**METROPOLITAN GOVERNMENT OF NASHVILLE AND DAVIDSON COUNTY**

**STAFF RECOMMENDATION**  
**3723 Central Avenue**  
**April 17, 2013**

**Application:** New construction – accessory building  
**District:** Richland-West End Neighborhood Conservation Zoning Overlay  
**Council District:** 24  
**Map and Parcel Number:** 10409004900  
**Applicant:** Lynne P. Wilkinson, Owner  
**Project Lead:** Sean Alexander, sean.alexander@nashville.gov

Floor Plan  
**A**  
**1.01**

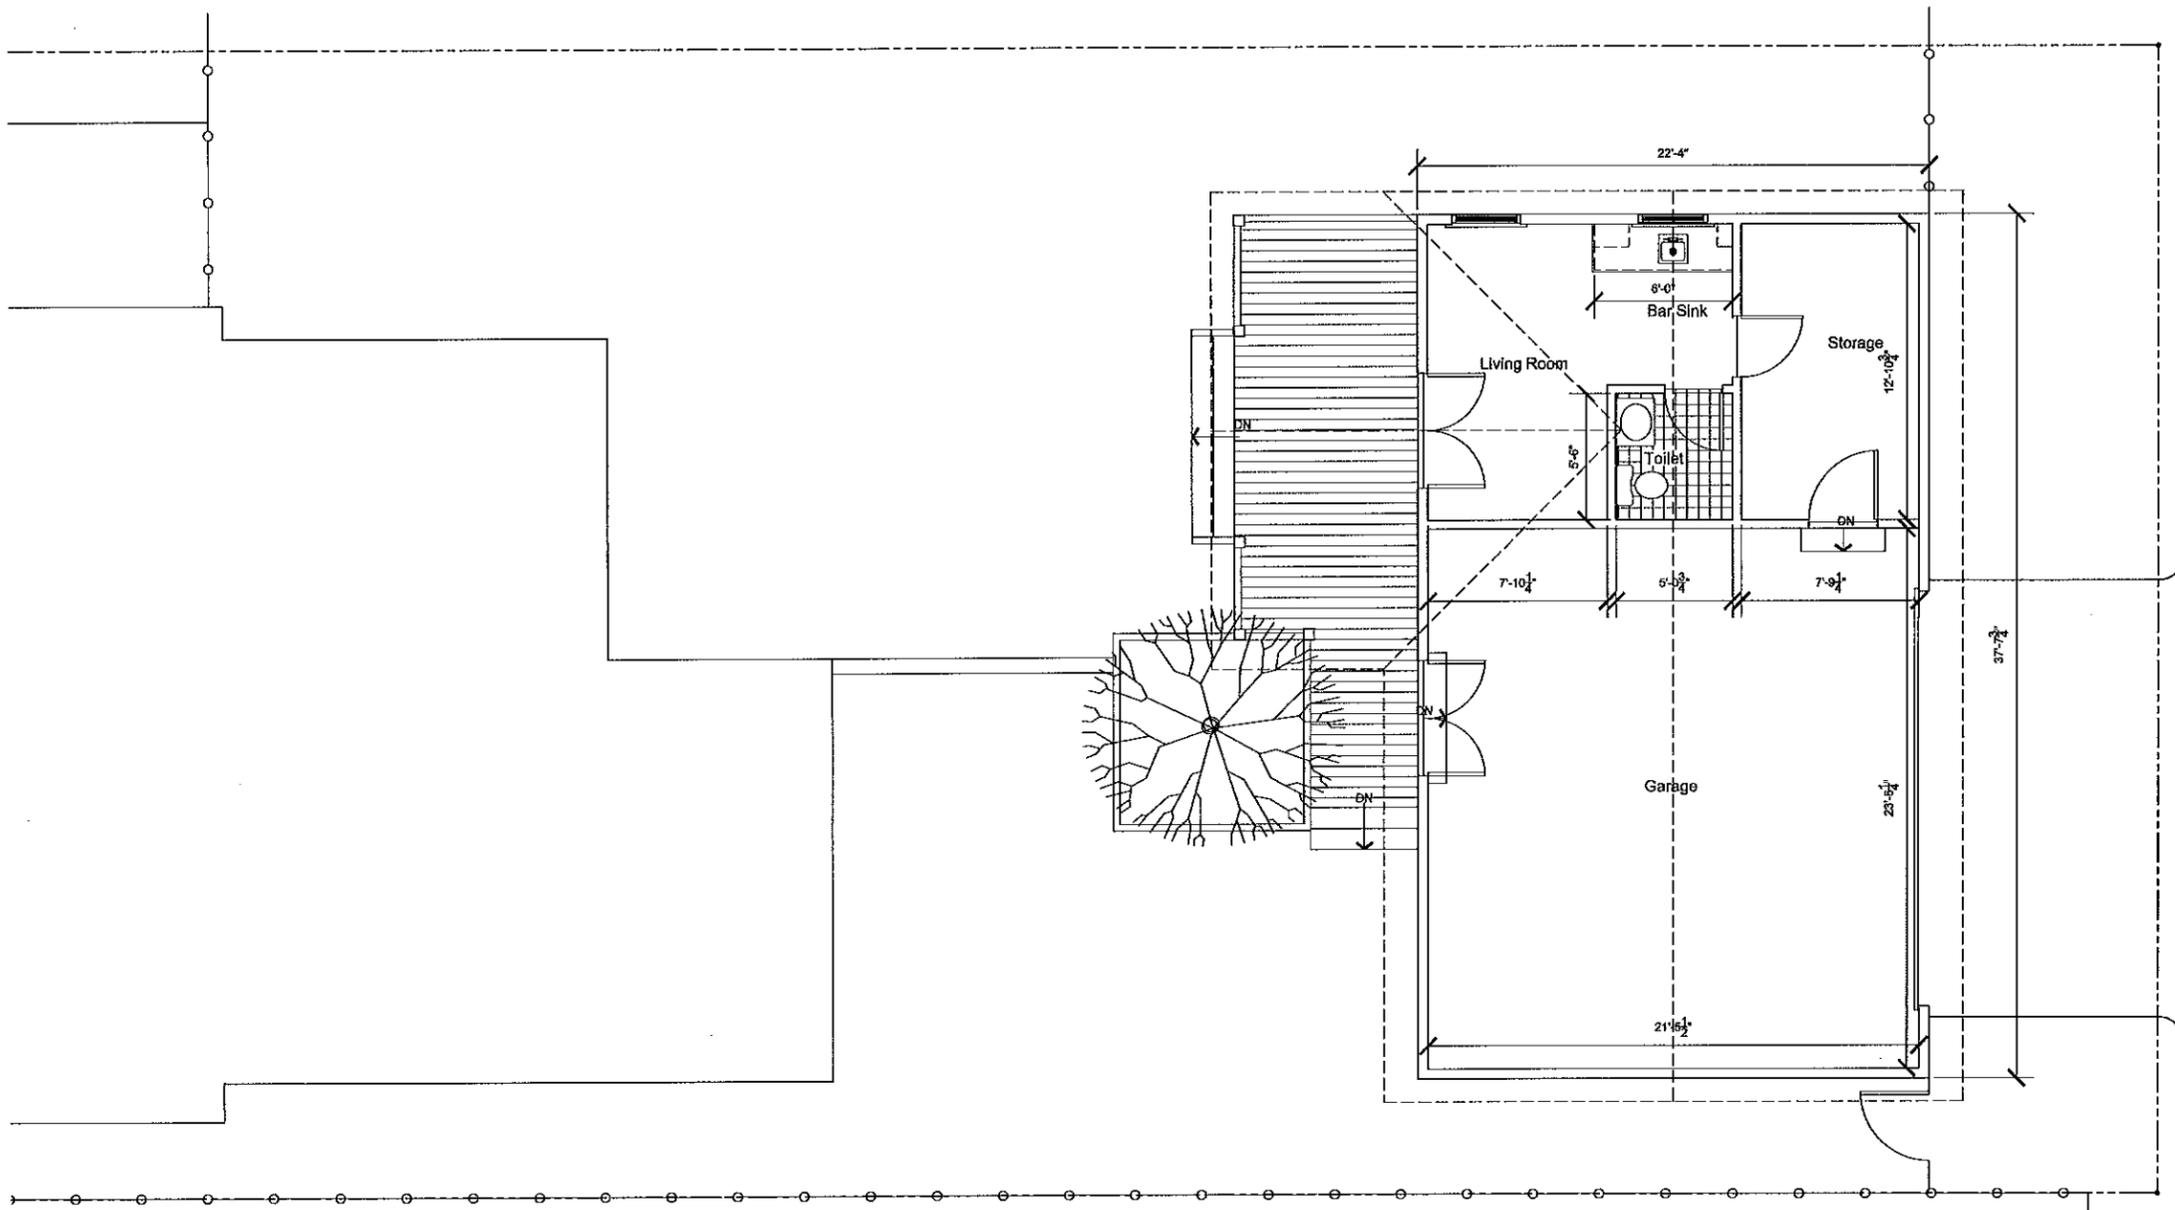
The building will be located behind the primary building and will be accessed from the rear alley. A reduction of the bulk zoning rear setback from twenty feet (20') to ten feet (10') is requested. The building will meet the current setback of five feet (5') on the right side. Staff finds the proposed location to be appropriate and to meet guideline II.B.1.c.

Exterior Elevations

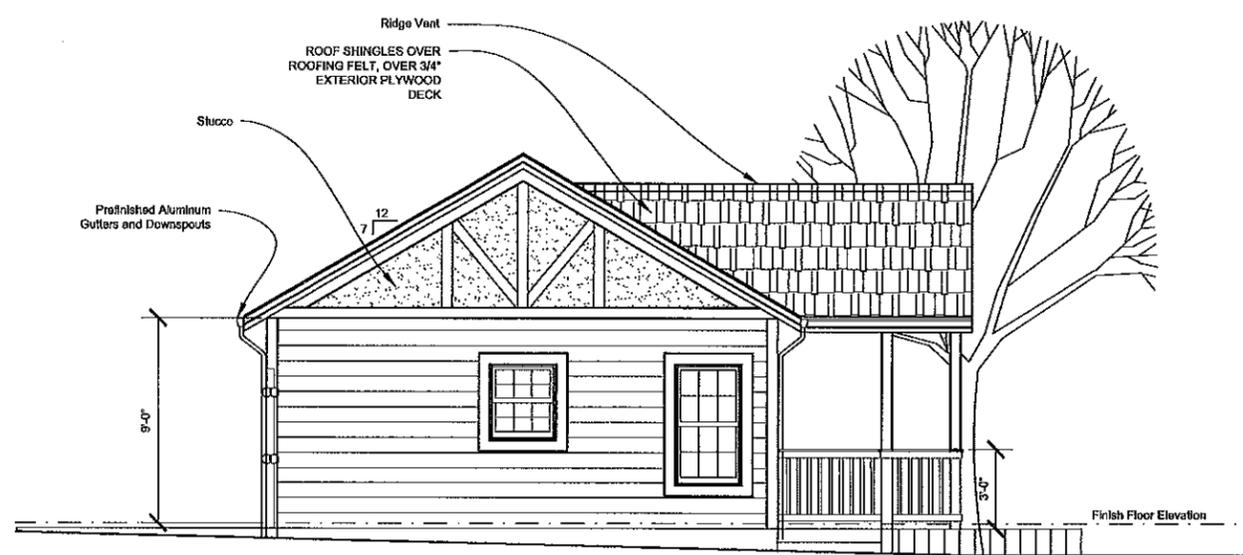
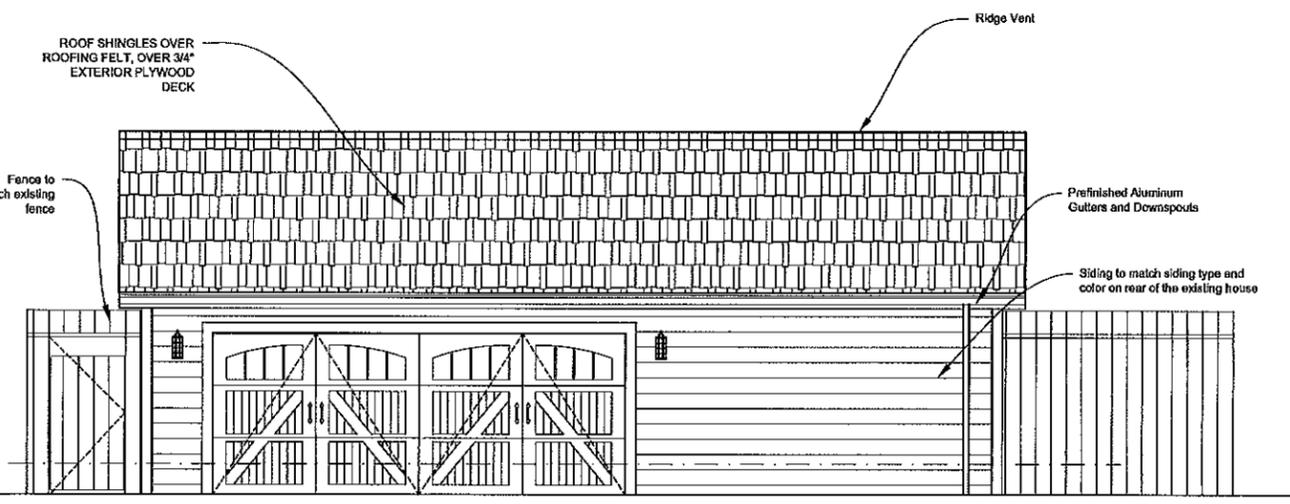
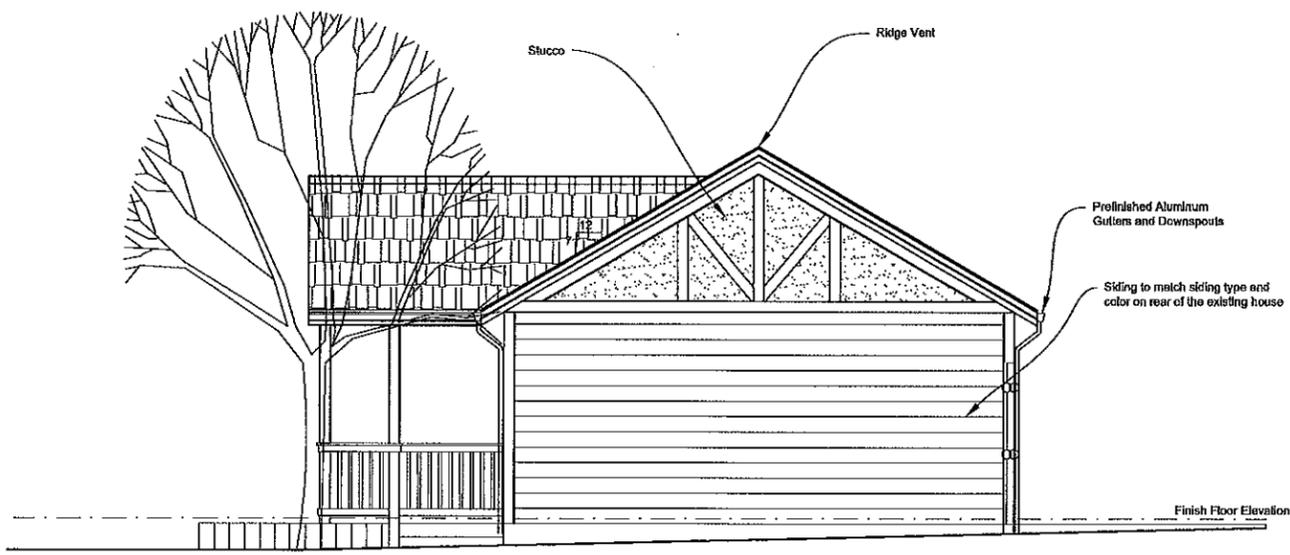
The new accessory building will be one-story tall with a roof height of seventeen feet (17’) above grade and an eave height of nine feet (9’). The total footprint of the building will cover nine hundred, ninety square feet (990 sq. ft.), including a one hundred, fifty square foot (150 sq. ft.) covered porch. The width of the building roughly matches the width of the primary building, but it will be ten feet (10’) shorter than the original roof.

The exterior materials of the new accessory building will match those of the addition approved in 2011: smooth-faced cement fiber siding with stucco in the gable fields, composite shingle roof, and wood trim. The windows will be aluminum-clad to match those on the existing house. Staff finds these materials to meet guideline II.B.1.d.

The roof of the new building will be a side-facing gable, with a front-facing gabled porch. The pitches of the roofs will be 7:12. Staff finds that the roof will be compatible with that of the house and surrounding historic accessory buildings, and that it meets guideline II.B.1.e.

Staff recommends approval of the proposed detached accessory building at 3723 Central Avenue, finding the proposal to meet the design guidelines for new construction in the Richland West-End Neighborhood Conservation Zoning Overlay.
